Project Title: Davis-Woodland Water Supply Project ("DWWSP")

A RESOLUTION OF THE BOARD OF DIRECTORS
OF THE WOODLAND-DAVIS CLEAN WATER AGENCY
APPROVING CEQA ADDENDUM NO. 4 TO PROJECT FINAL EIR,
APPROVING CHANGE OF PROJECT DAVIS TREATED WATER
PIPELINE ALIGNMENT, AND MAKING RELATED FINDINGS

DAVIS-WOODLAND WATER SUPPLY PROJECT

Environmental Impact Report Addendum No. 4

Figure 1
2007 DWWSP Final EIR Figure 1-3 - Preferred Project

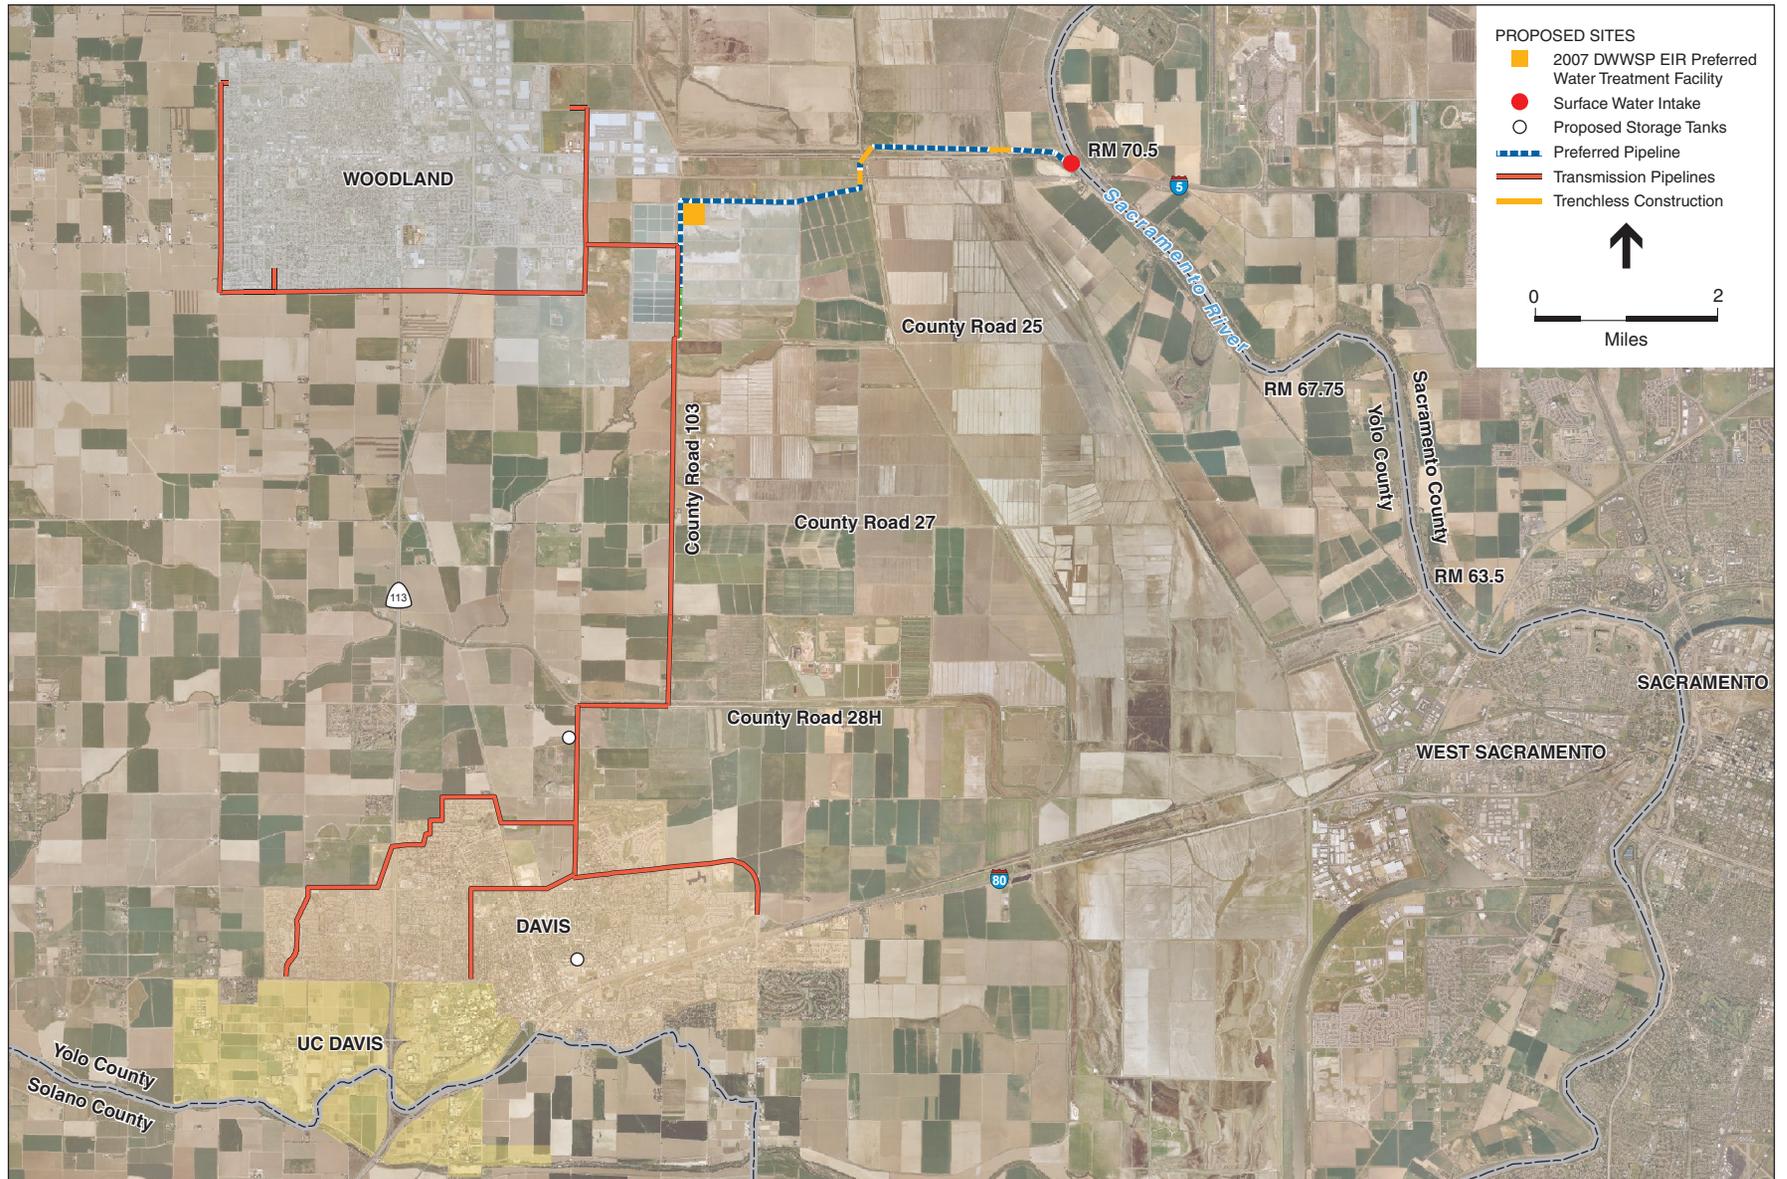
Figure 1 shows the layout of the proposed project as analyzed in the 2007 DWWSP EIR. The approved project is described in Chapter 2 of the 2007 DWWSP EIR. Figure 2-9 of the 2007 DWWSP EIR shows the proposed Davis finished water transmission main pipeline heading east from the proposed RWTF and south along an existing farm road to the intersection of County Road 25 and County Road 103, then south along the edge of County Road 103 to just north of County Road 28H. The finished water transmission main would then run west along County Road 28H and then immediately south along County Road 102/Pole Line Road until the terminus of the transmission main on property owned by the City of Davis (Figure 1).

As described above, the Davis finished water transmission main pipeline was intended to be placed within County Road 28H. However, the road is built atop the Willow Slough Bypass north levee, and therefore subject to the Central Valley Flood Protection Board design limitations of California Code of Regulations, Title 23, which does not allow for the placement of pipelines within and parallel to existing levees. As shown on Figure 2, the current proposed transmission main alignment will continue south through the Willow Slough Bypass and agricultural (grazing) land, the head west along the south side of an existing farm road through agricultural lands until connecting with the original proposed alignment adjacent to County Road 102/Pole Line Road north of the City of Davis urban area. The length of this new segment is approximately 8,200 feet. The length of the previous alignment was approximately 8,700 feet. The desire to change this alignment is to

avoid a conservation easement west of County Road 102, to avoid disturbance of wetlands immediately north of County Road 28H, to minimize the number of landowners impacted by construction activities, and to reduce the length of pipeline required.

Construction through County Road 28H and through the Willow Slough Bypass will be by open cut construction method. County Road 28H will be closed during the day to traffic for up to 14 days. Detour routes along County Road 27, County Road 32A, and County Road 105 will be identified through flagging and signage for local and landfill traffic. All road closure provisions will be performed consistent with an encroachment permit obtained from Yolo County and through coordination with the Yolo County Central Landfill. To minimize the impact on traffic on the heavily traveled County Road 102/Pole Line Road, the pipelines will be constructed by trenchless methods under the road and will be located just west of the road heading south to the termination point on property owned by the City of Davis.
